CITY PLANNING COMMISSION

APPLICATION: A. Environmental Determination  
 B. Tentative Map (Sub. Ord. Ch. 40) (P84-224)

LOCATION: East of Western Pacific RR, West of Deer Lake Road

PROPOSAL: The applicant is requesting the necessary entitlements to divide 65± vacant acres into 305 single family residential lots

**MESA GRANDE UNIT #5**  
 CITY OF SACRAMENTO, CALIFORNIA  
**TENTATIVE SUBDIVISION MAP**

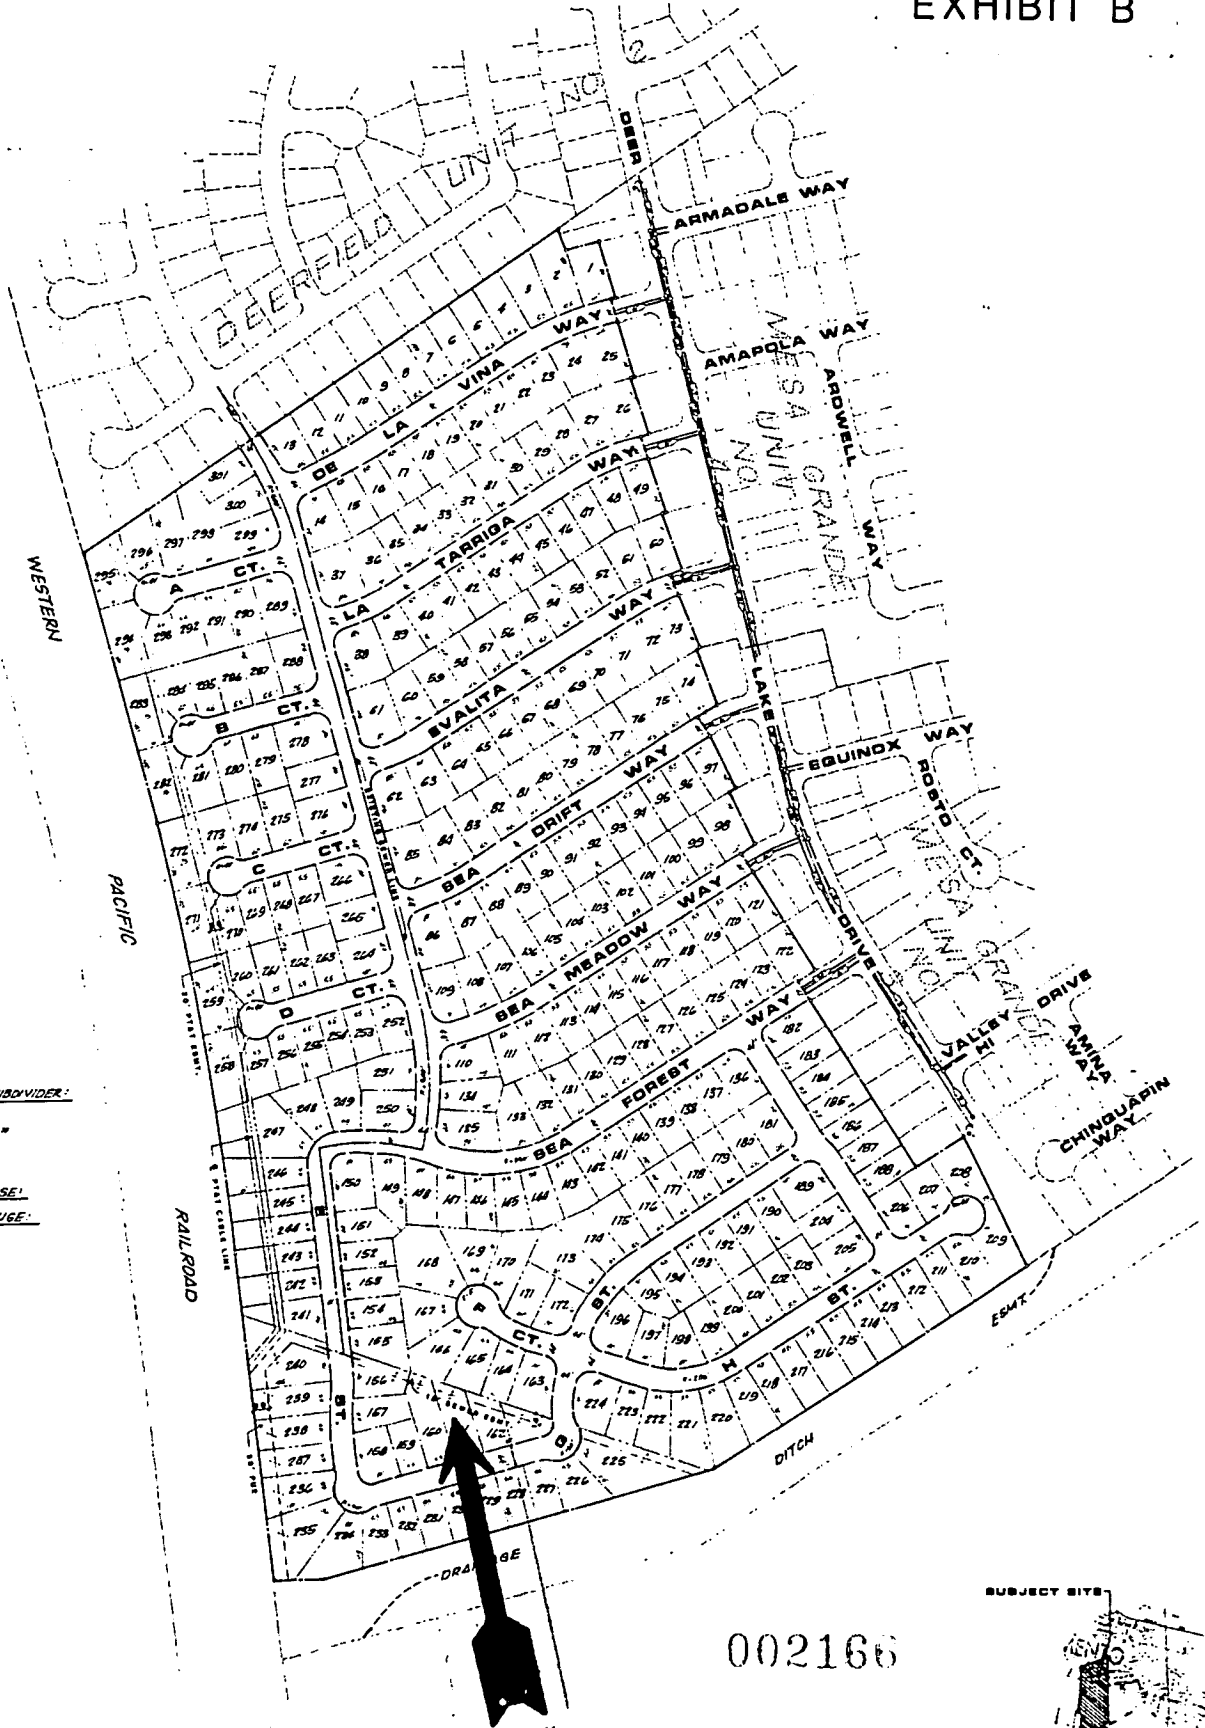
- B. An existing sewer line located in the southwest corner of the site created some irregularly shaped lots with sewer lines running along rear property lines (See Exhibit B). This situation creates access problems for the City when repair of the sewer line is necessary. To alleviate this problem, the applicant proposes to relocate the sewer line into the street right-of-way. This redesign has resulted in 4 additional lots from the previous approval necessitating new map approval. Staff has no objection since the density is well with the limits of the R-1 zone and Community Plan designation.

1. Provide standard subdivision improvements pursuant to Section 40.811 of the City Code;
2. Prepare a sewer and drainage study for the review and approval of the City Engineer; may require relocation of a portion of existing sewer;
